Council Assessment Panel Minutes

18 November 2024

**5.1 DEVELOPMENT NUMBER 24016085 – JUDY BARNETT
- 16 EDMUND STREET, NORWOOD**

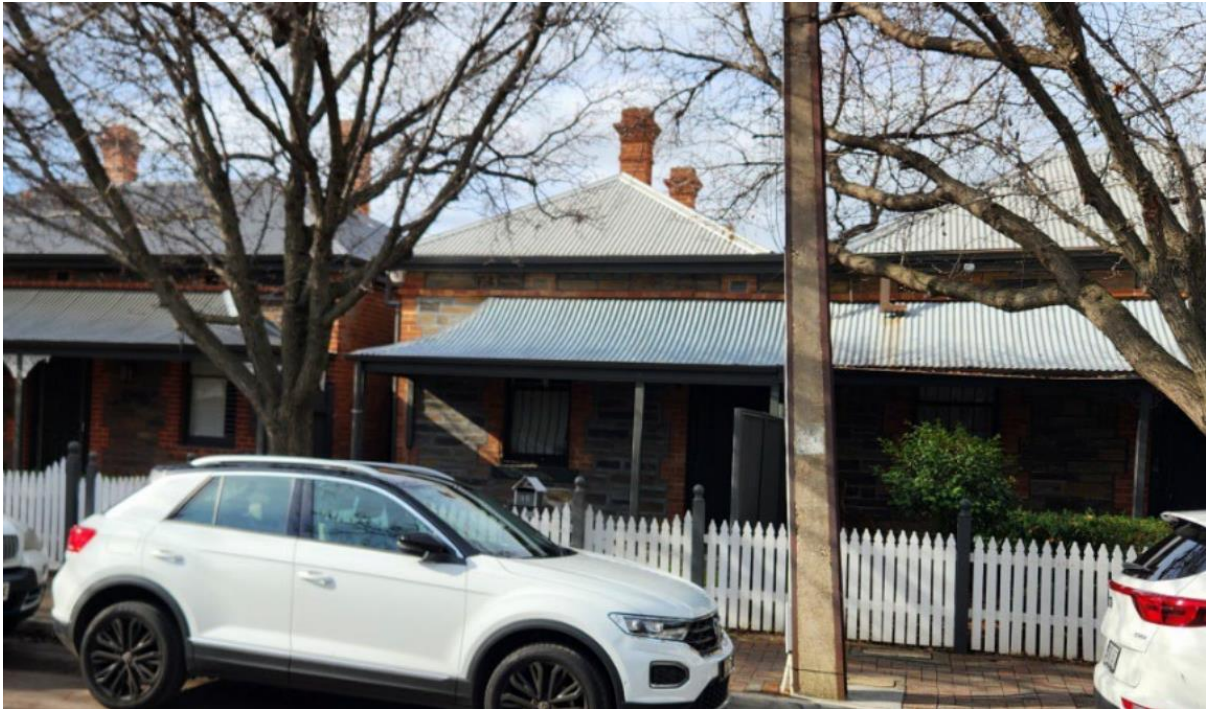
While the proposed addition will be visible from the street, its visibility will be limited. The photo below, taken by Council's Heritage Advisor, shows that the rear chimney is visible from the street, but only to a limited extent. The proposed addition, which would sit behind this chimney, and at roughly the same height, would therefore be slightly less visible than this chimney.

Considering the proposed materials, the relatively simple surfmest weatherboard complements the representative building because the contrast in colour, and consistent backdrop will mean that the chimney will be more visible, consistent with PO 2.5.

The simple form and relative lack of architectural detailing for the addition results in a visually recessive outcome, meaning that the addition does not compete for attention with the original dwelling. This is consistent with the intent of PO's 2.1, 2.3 and 3.1.

Nonetheless, overall, the extent to which it will be visible from the street is considered to be quite limited. It therefore does not dominate the primary facade and is consistent with PO 3.1.

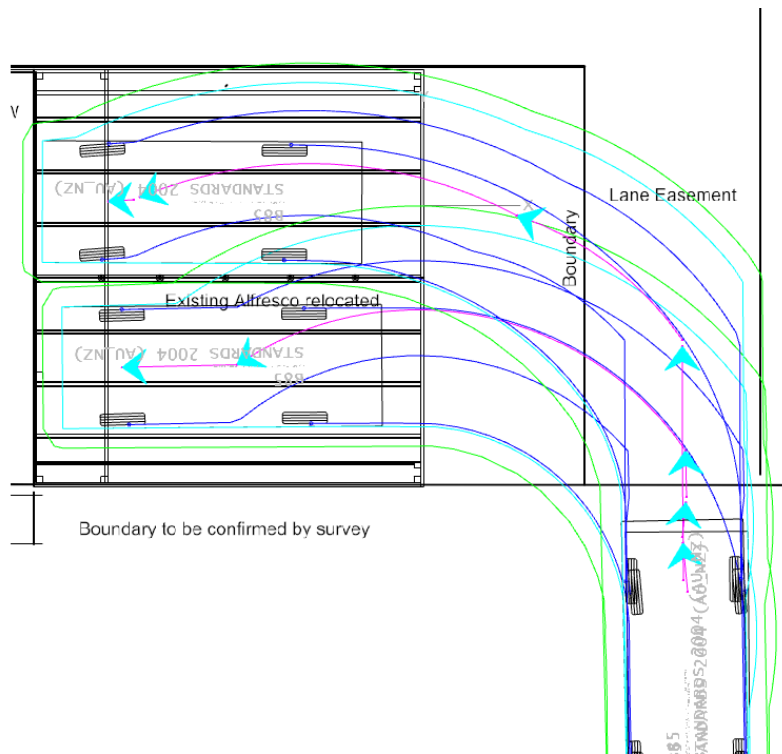
I have sought to verify the shadow diagrams provided in the response to representations, and they appear to be broadly correct. The plan does note that they are not to scale, but by comparison to the scaled plans provided, they do appear to be of an irregular scale (roughly 1:245) They indicate the following areas as receiving direct sunlight:

- 9am- 33.5m²
- 11am- 38.7m²
- 1pm- 20.6m²
- 3pm- 27.9m²

Therefore, while the proposed development would increase the extent of overshadowing, they appear to still meet the guidelines outlined by DPF 3.2 (a) (i)

The representor from 20 Edmund St, Norwood raised concerns regarding solar panels. It is evident from the shadow diagrams provided that there will not be any tangible impact on the performance of these solar panels, in line with PO 3.3.
